### **TUALATIN ARCHITECTURAL REVIEW BOARD**

**April 9, 2014, 7:00 PM**

- A. Southwest Industrial Park Recommendation and Staff Report for AR-14-02

**1 WEST ELEVATION**  
CA3.1 1/16"=1'-0"

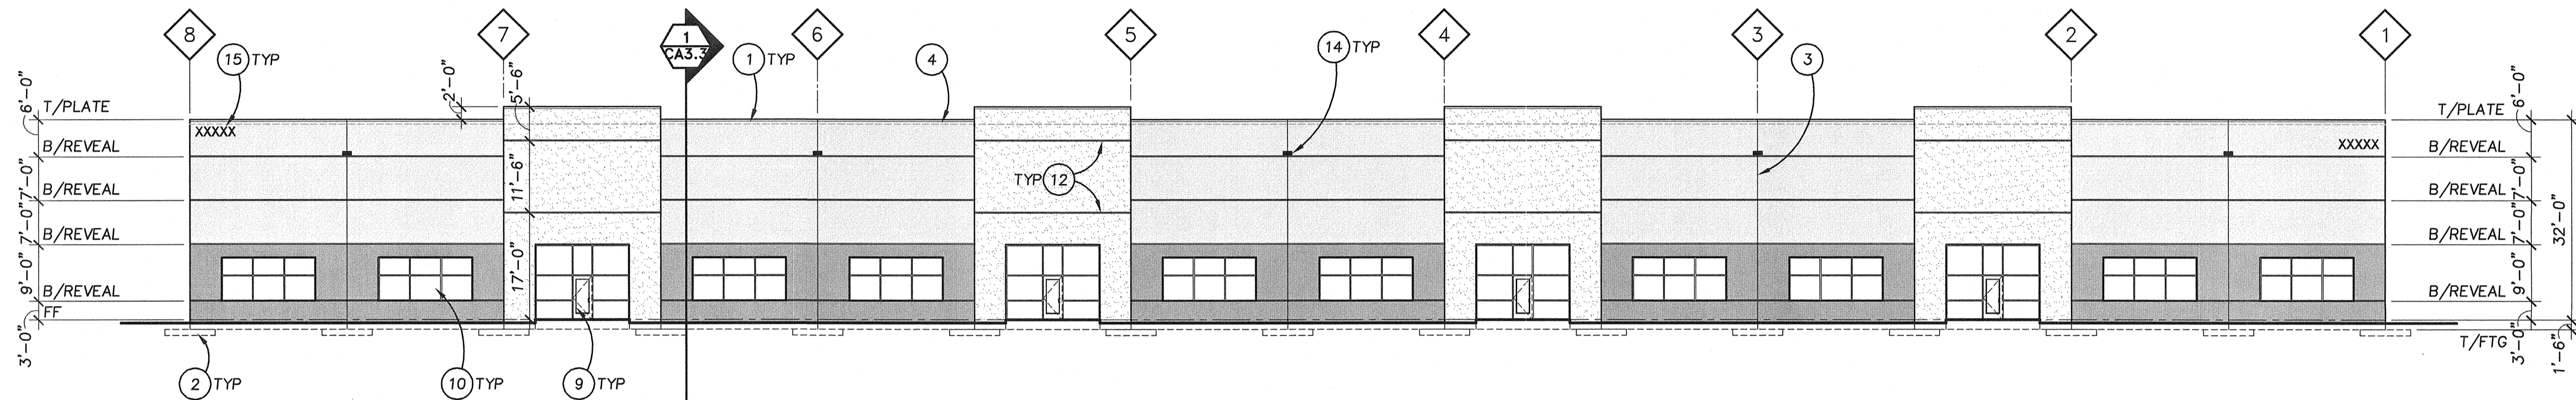
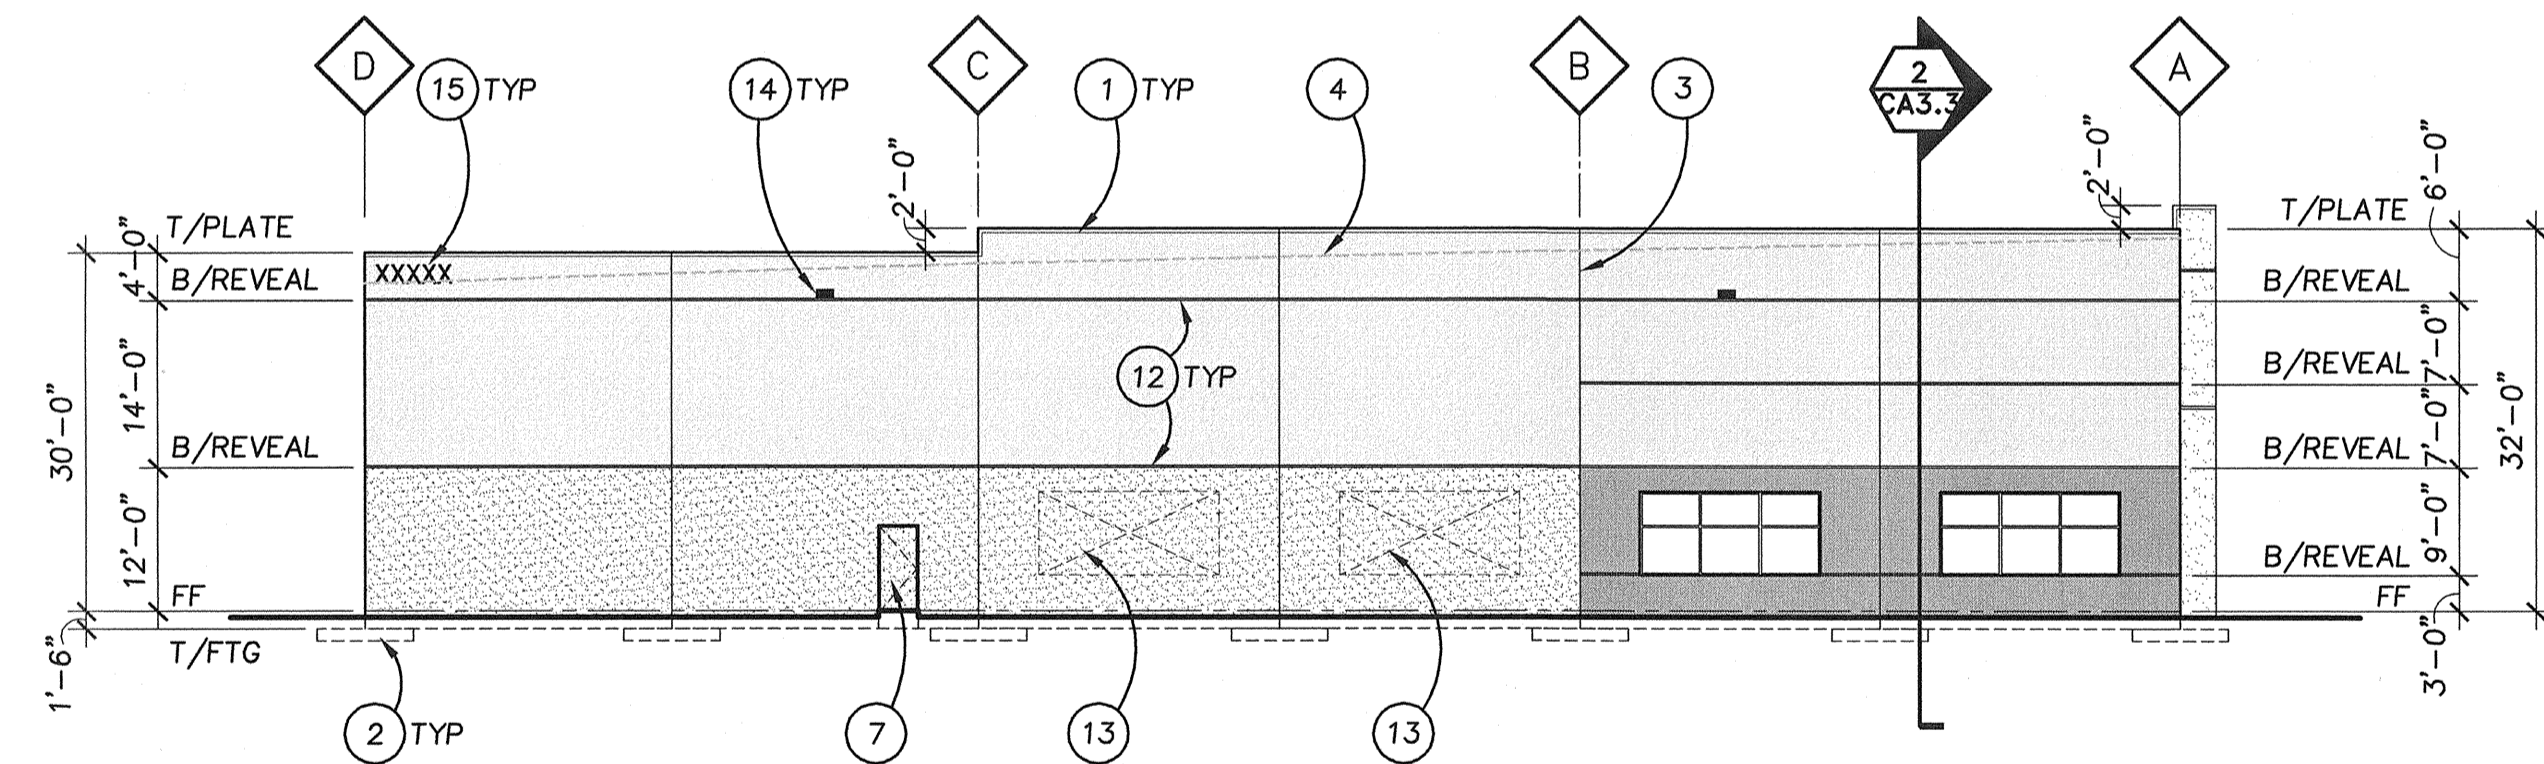
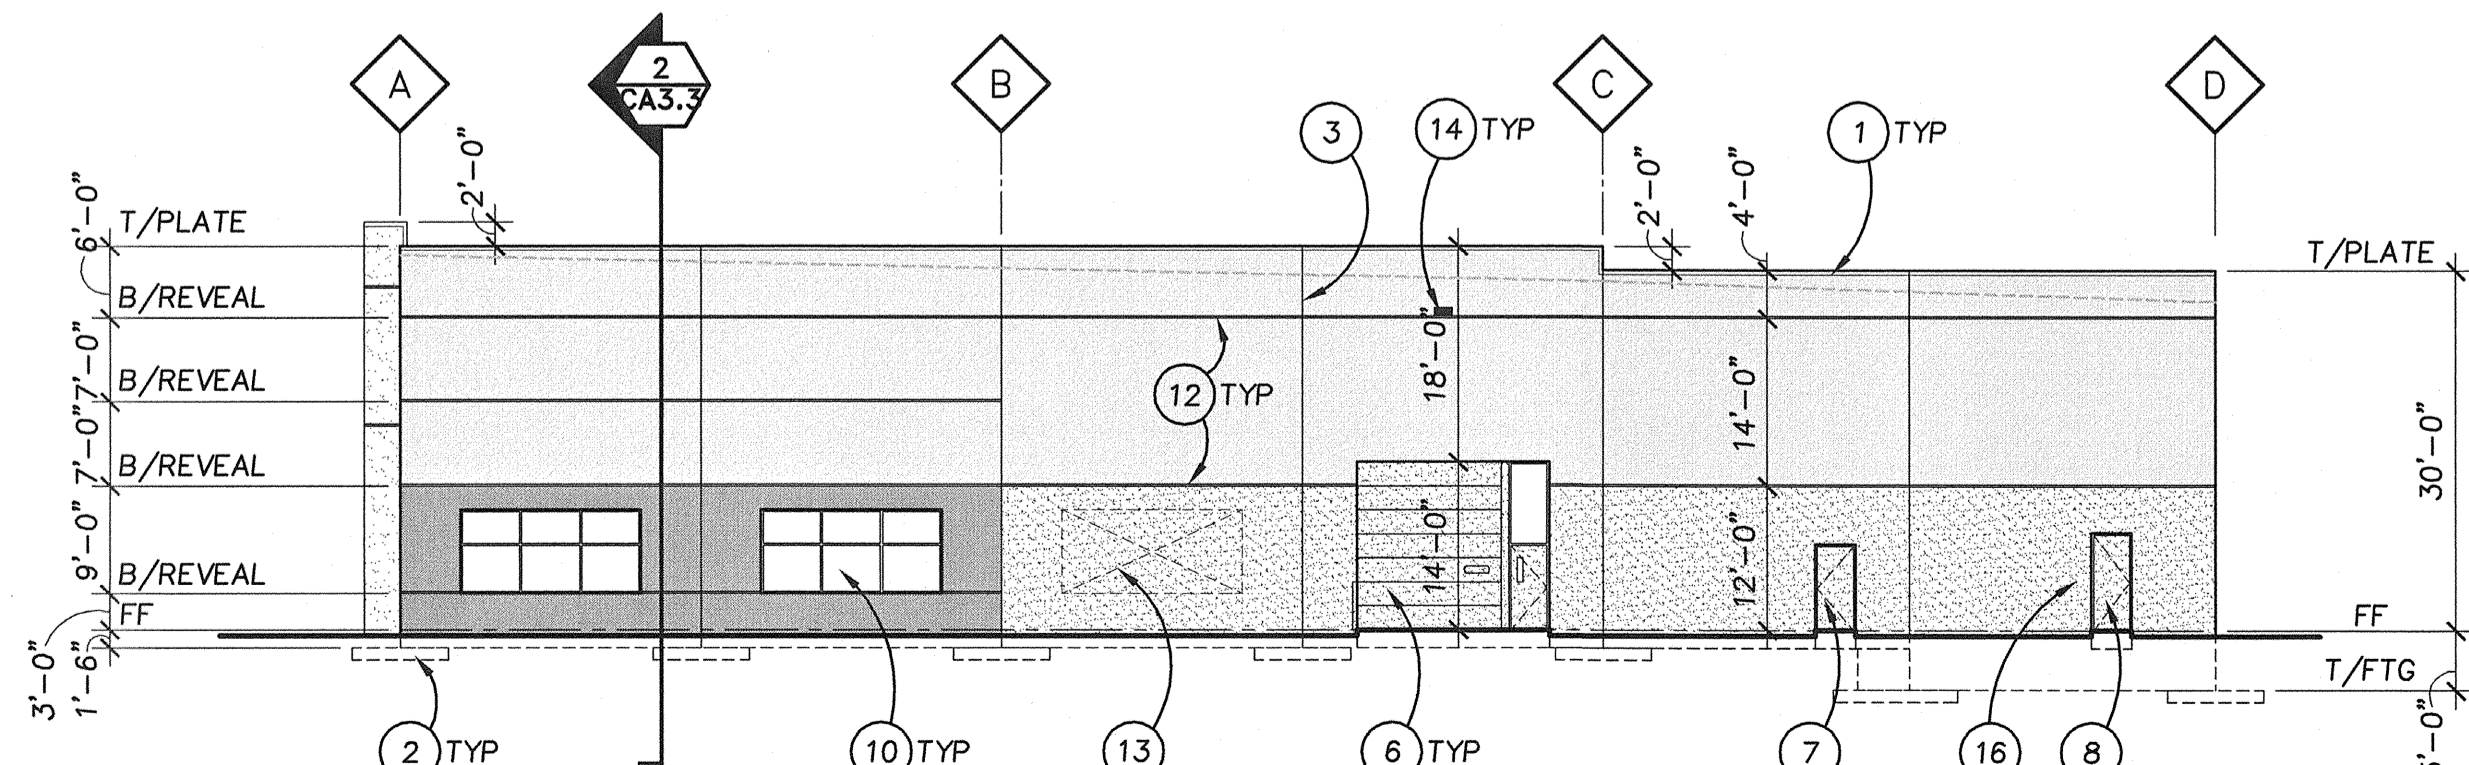
The building elevations (Sheets AA3.1, BA3.1, and CA3.1, Keynotes 14; and DA3.1, Keynote 17) note wall pack lights without providing some specification of the wall-mounted fixture(s). Though providing light, because the elevations proposed the wall-mounted fixtures at 26 ft above grade, tenants, employees, and pedestrians would see less well because of the likely glare and direct visibility of the bulbs from most areas near Buildings A-D, weakening the benefit of exterior lighting. To ensure compliance with this code section, staff recommends a condition that the applicant provide clarification about the wall-mounted fixtures and the angles of bulb visibility and revise the proposal if needed based on the *Guidelines for Good Exterior Lighting Plans* (Attachment 110), specifically information that relates to the “Acceptable” lighting fixtures and “Full-cutoff fixture” lighting angle diagrams in the guidelines on pages 2 and 4 respectively. Staff recommends a condition of approval to this effect.

For exterior wall-mounted lighting, the building elevations (Sheets AA3.1, BA3.1, and CA3.1, Keynotes 14; and DA3.1, Keynote 17) note wall pack lights without providing some specification of the wall-mounted fixture(s). As examined for the requirement of 73.160(3)(a), the wall pack lights are proposed at 26 ft above grade, a height that might make glare and direct bulb visibility intrude into the ROWs of SW 118<sup>th</sup> Avenue and SW Myslony Street. Because staff cannot determine compliance, the applicant needs to provide clarification about the wall-mounted fixtures and the angles of bulb visibility. Staff recommends a condition of approval to these effects for the requirement of (6).
